ARTHUR R. OUTLAW CONVENTION CENTER KITCHEN FLOORING REPLACEMENT Mobile Alabama CN-26-23

June 2, 2023

SECTION 009003-ADDENDUM 03

A500

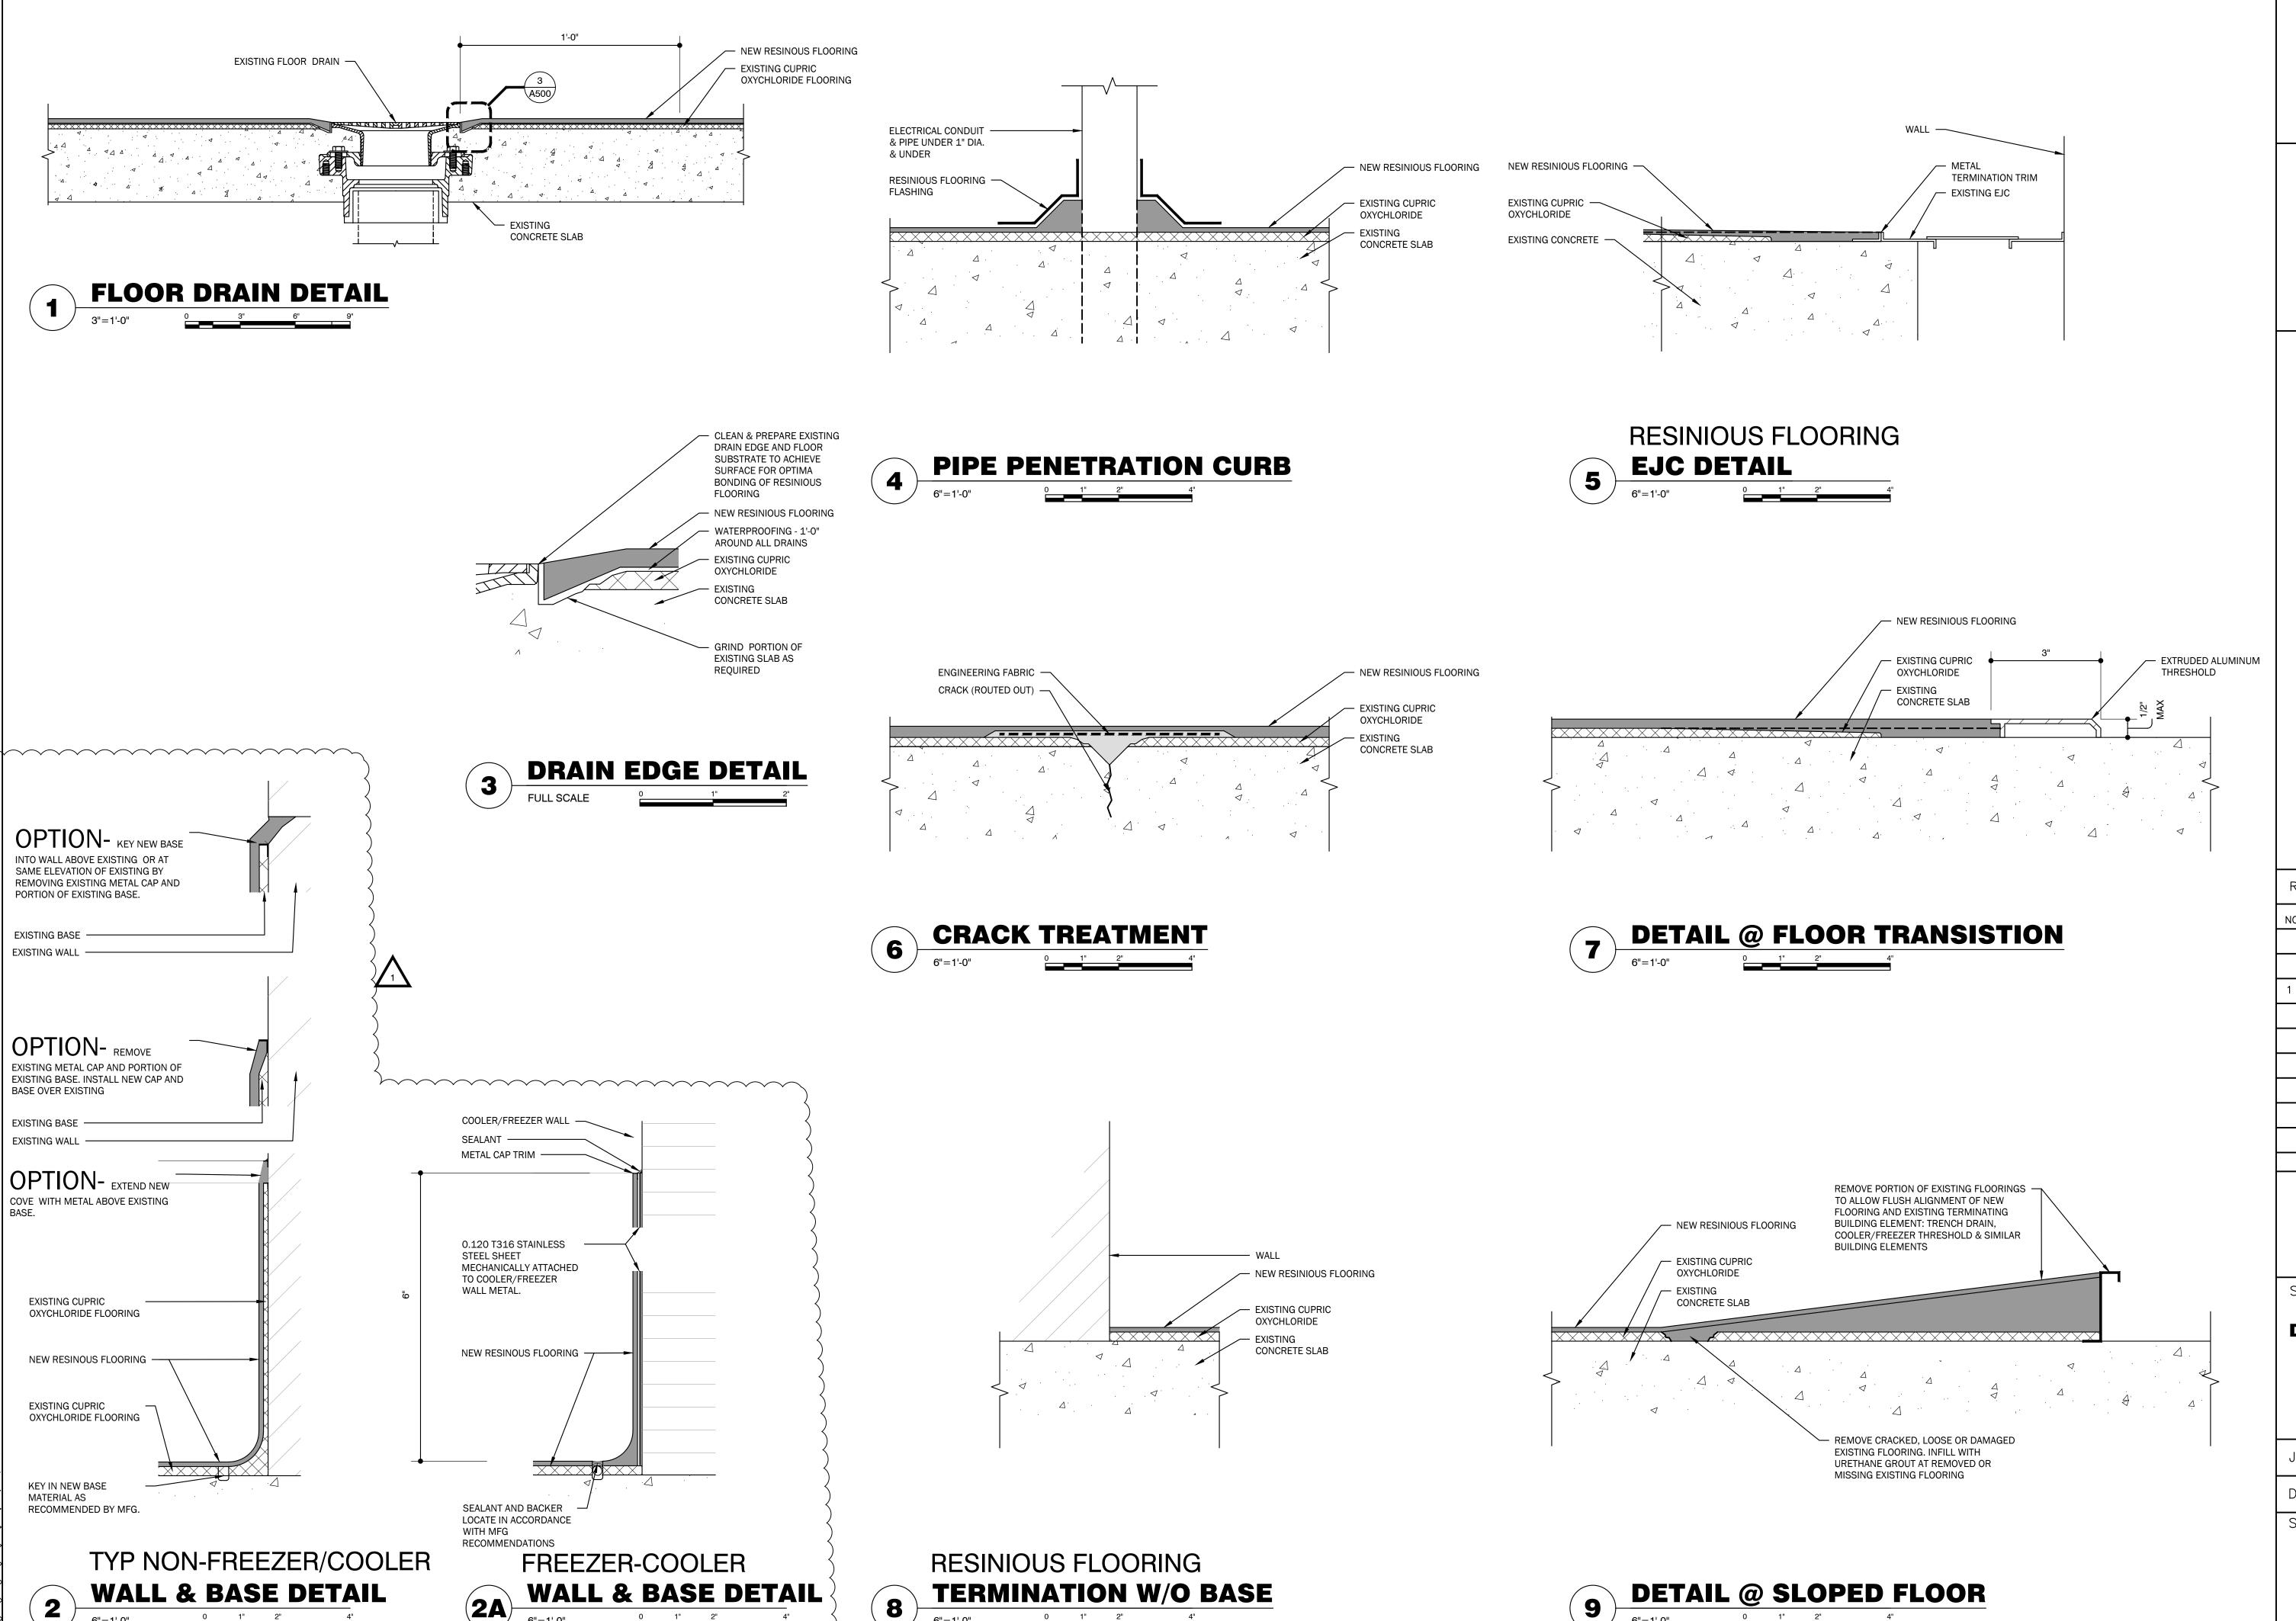
- 4.1 General: Provide resinous base at interior and exterior of all cooler/freezers. Reference Sheet A500
- 4.2 Sheet A500: Re-issued as attachment to this Addendum.
